Decision Report

**Quakers Hill Water Resource Recovery
Facility Advanced Treatment Upgrade
(December 2025)**

Table 6-27 Offsetting options for vegetation

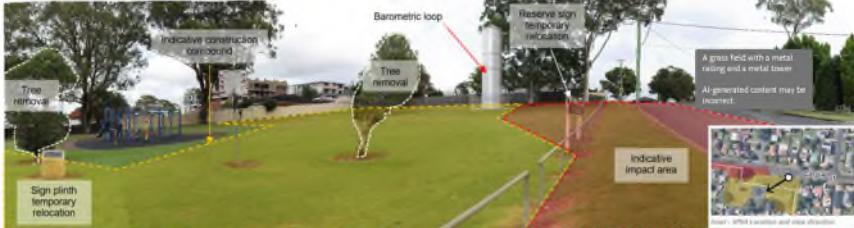
A minimum offset ratio of 2:1 should apply to any tree removals, meaning two new trees must be planted for every tree removed as a minimum.

For offset tree planting, Sydney Water must ensure that all trees are planted in a minimum 100-litre container size and are subject to a 12-month maintenance period to ensure successful establishment. The final planting locations, species selection, and associated details are to be discussed and agreed upon with Council.

- 3:1 - Threatened Ecological Communities
- 2:1 - Non-threatened native vegetation (e.g. native remnant, riparian or planted native vegetation)
- 1:1 - tree removal (non-locally native or exotic tree).
